**City of Ramsey**  
**Agenda**  
**Environmental Policy Board (EPB)**  
**Monday, August 16, 2021**  
**6:30 pm**  
**Council Chambers, 7550 Sunwood Drive NW**

Consider Natural Resources Aspects of Site Plan and Plat for G-Will Liquors

**NORTH BROOK  
MEADOWS**  
 RAMSEY, MINNESOTA

**EXISTING CONDITIONS, TREE INVENTORY,  
 AND REMOVALS PLAN**  
 RAMSEY, MINNESOTA

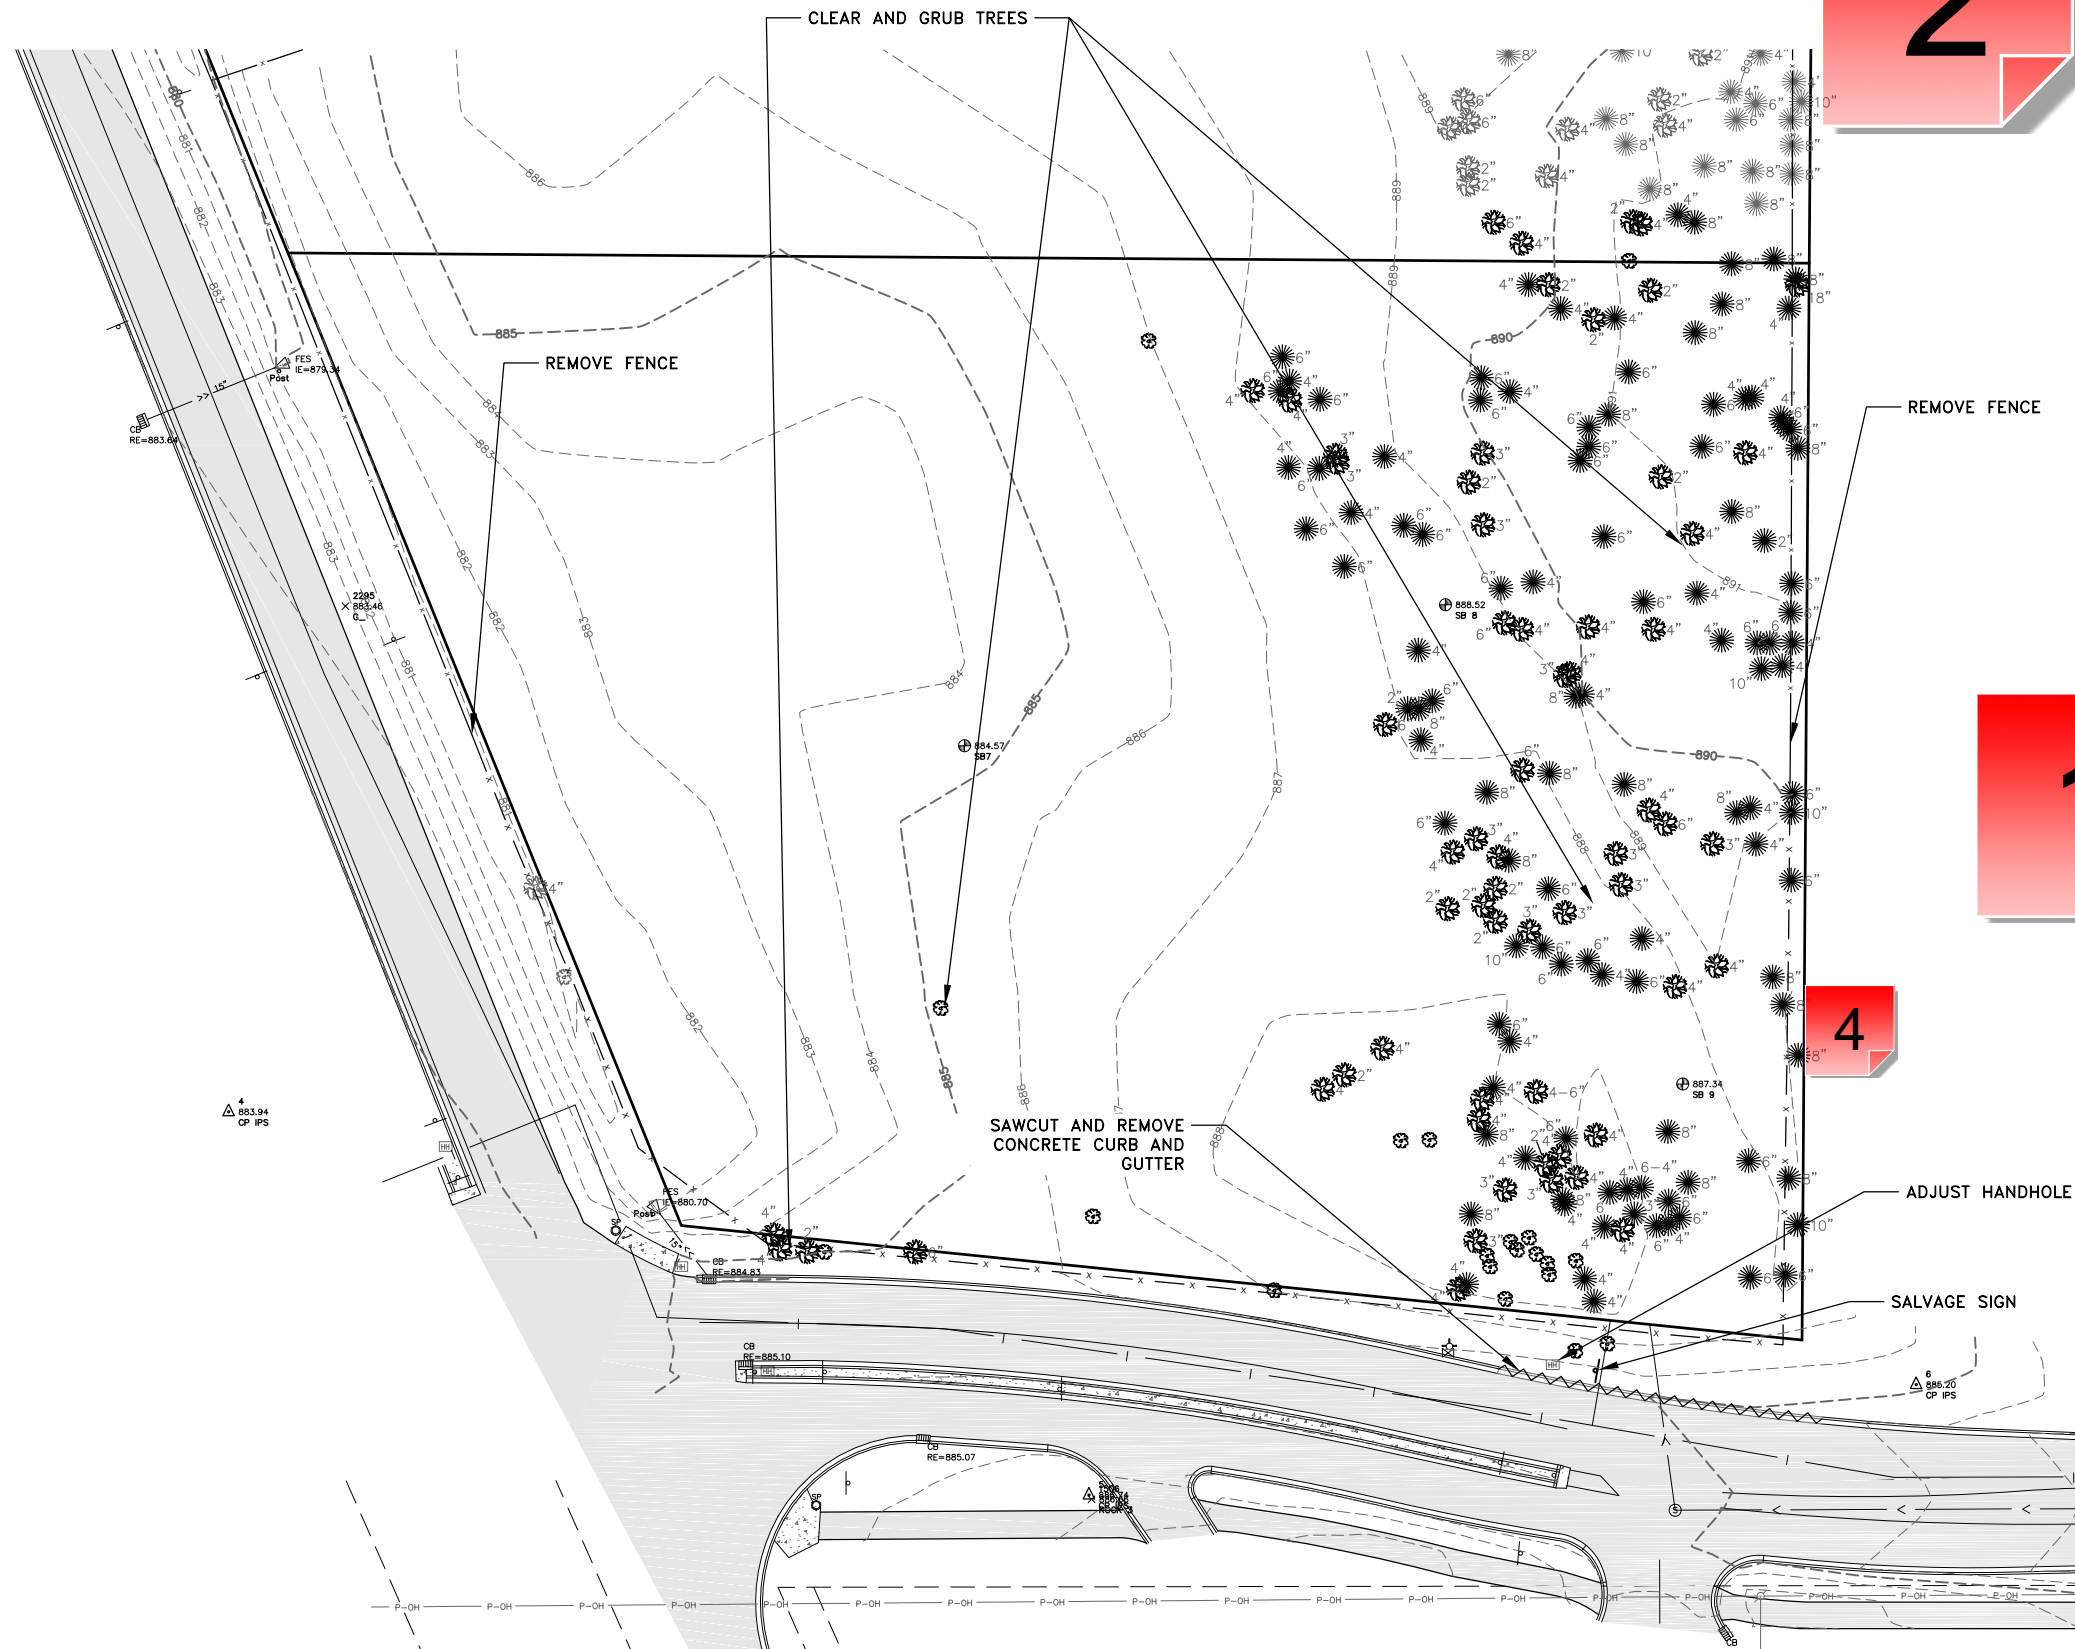
Need to include a table that identifies, at a minimum, species, DBH, status (preserve or remove), and if it is to be removed, a brief description of why (e.g. building pad, mass grading, stormwater pond, etc.).

If more than 70% of the significant tree DBH inches are removed, reforestation is required. For every 1 inch over the removal threshold, 1.25 inches shall be installed. This shall be shown in a separate Planting Schedule table on the Landscape Plan.

**LANDSCAPE PLAN**

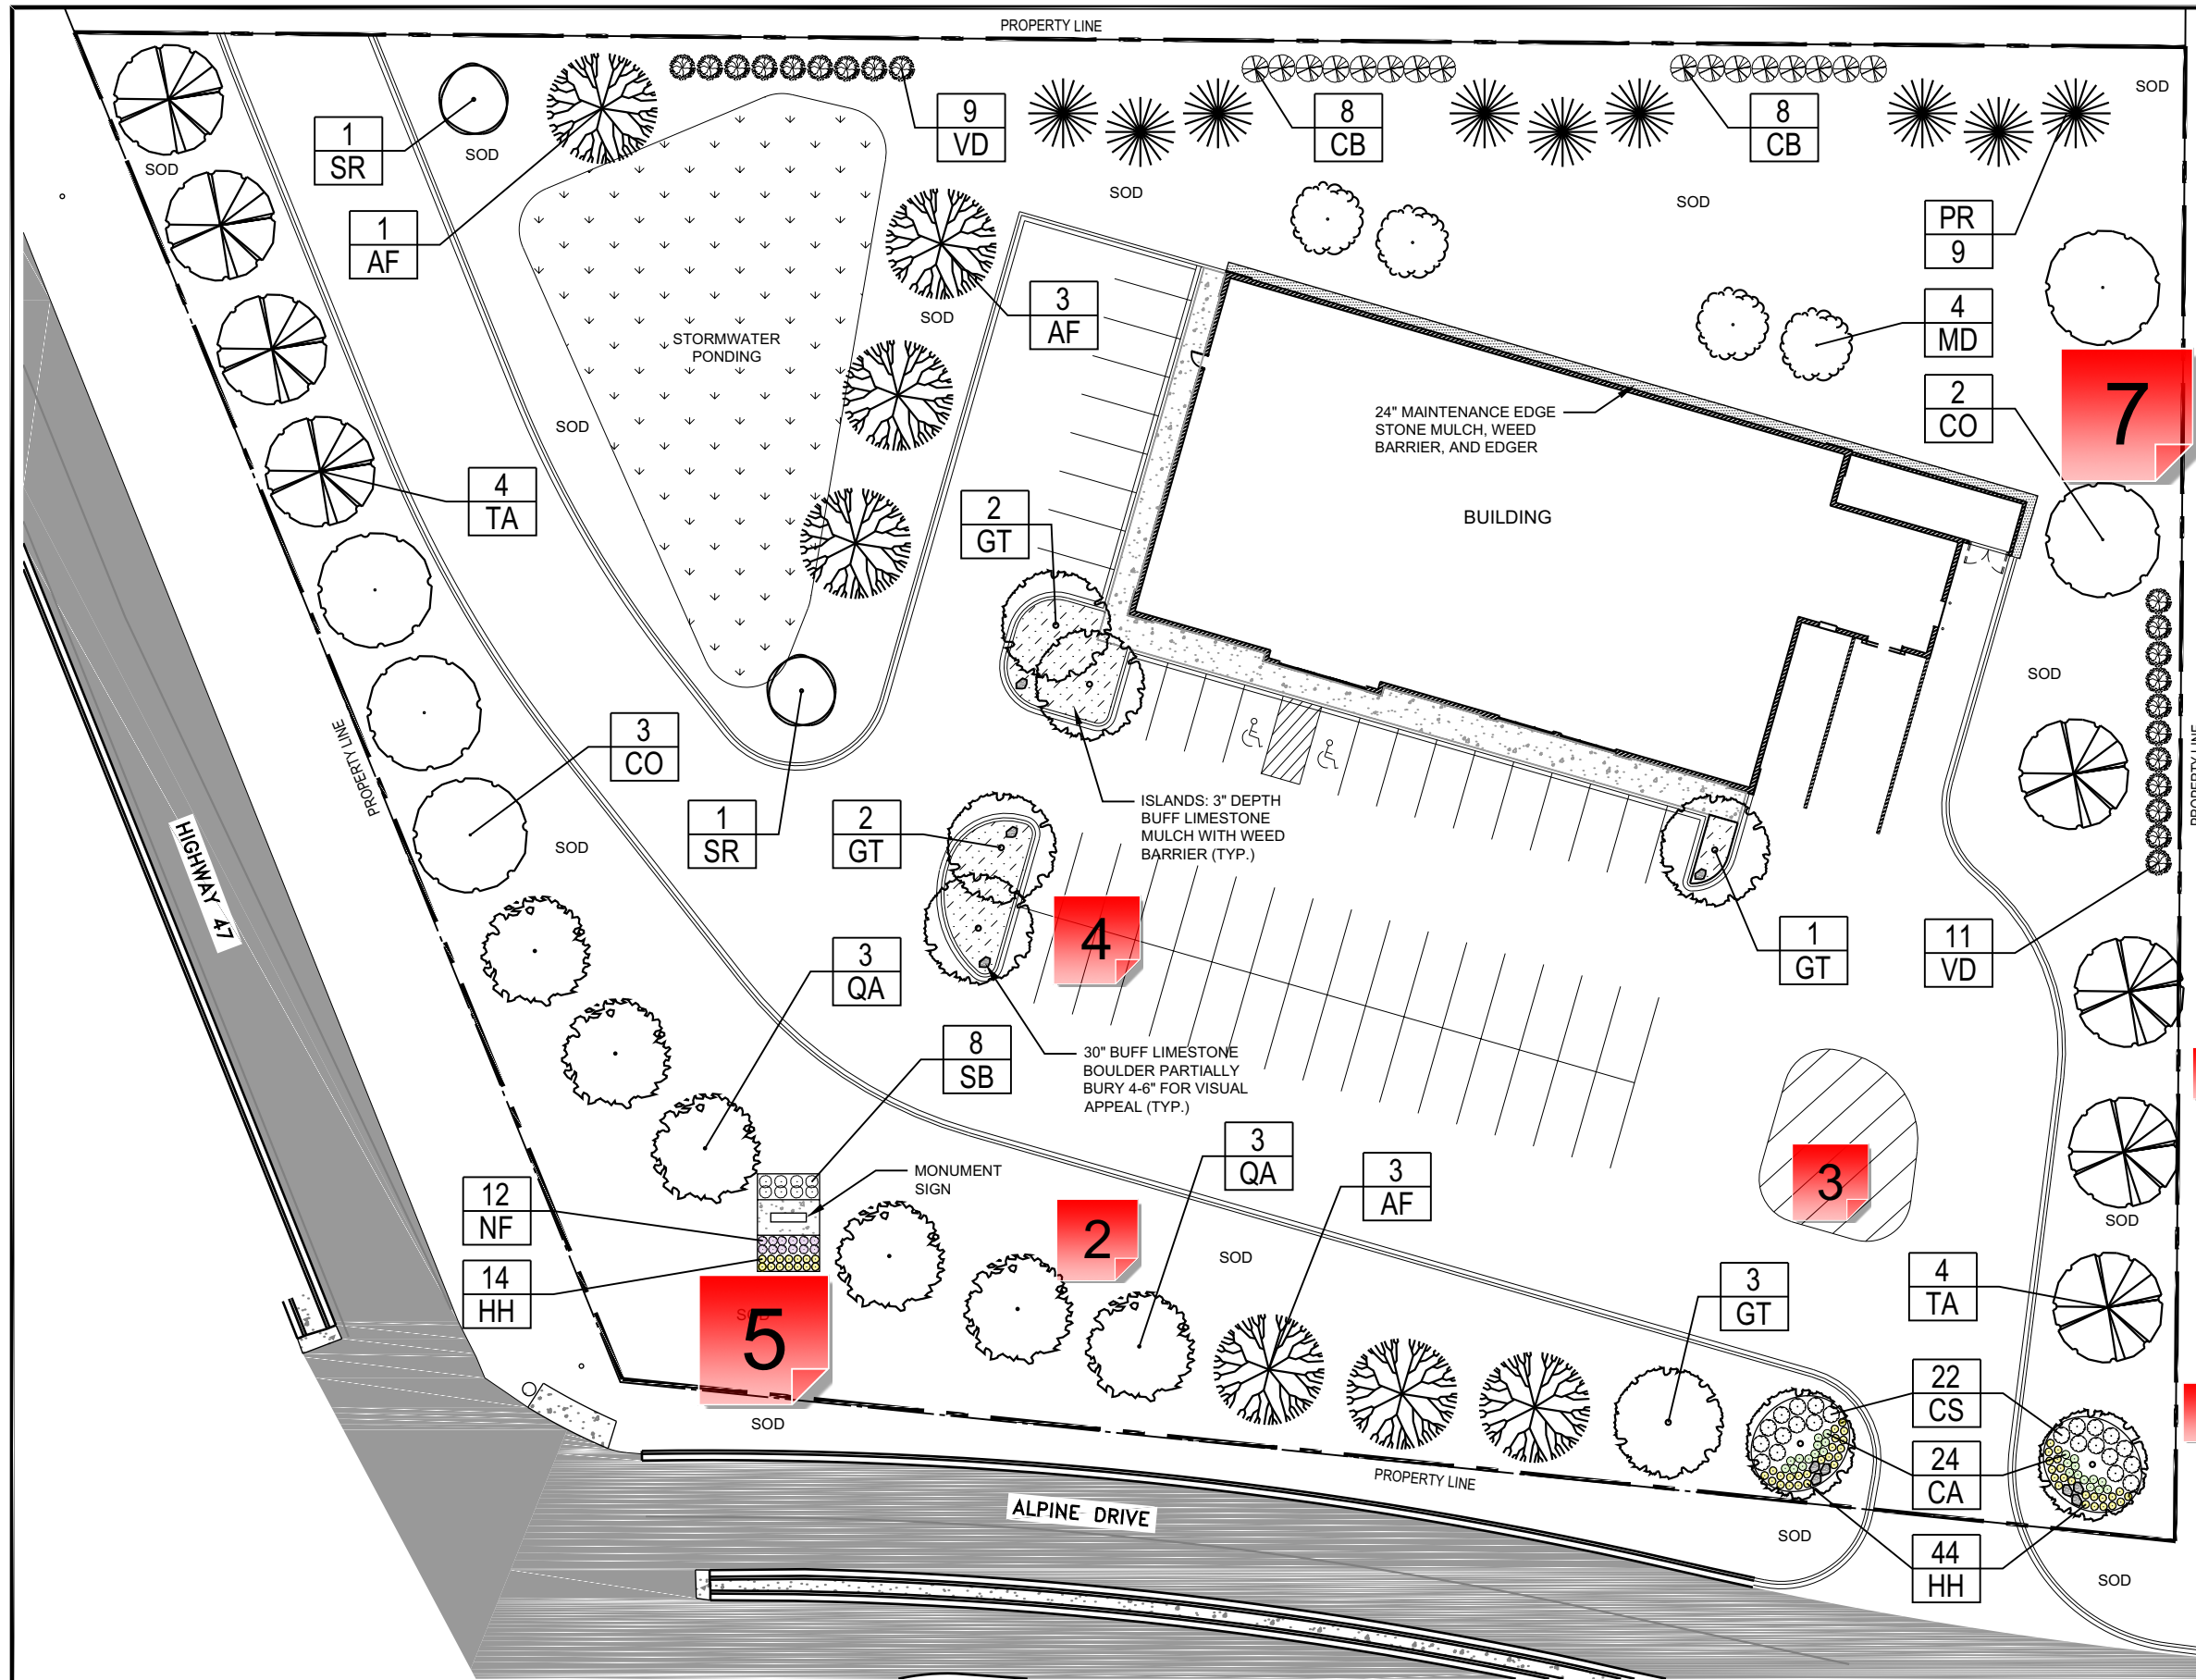
Isn't there the ability to preserve some of the existing trees along the eastern boundary? They could count toward the bufferyard plantings and base landscape planting requirements.

Only will be applied to the eastern boundary, which adjacent current use is R-1. So 25% additional plantings would be required. This equals 13 shrubs and 9 trees that should be focused along the eastern boundary. Overall, this means the total number of plantings could be reduced to 45 trees and 63 shrubs. This calculation does not account for any potential required reforestation plantings.

If desired, these plantings can be grouped and/or staggered to allow more creativity. Also, when the driveway width is eliminated from the frontage calculation, the number of required frontage trees drops to 18.

Landscape rock shall not be used as mulch in parking lot islands. Update plans to something such as wood chip mulch, which helps moderate soil temps and retain moisture better than rock.

Not reviewed as part of Landscape Plan. Separate Sign Permit required. Height cannot exceed 25 feet, sign area cannot exceed 100 square feet.

Need to rearrange some of the plantings to ensure that at least 13 shrubs and 9 trees are positioned along the eastern boundary for bufferyard purposes.
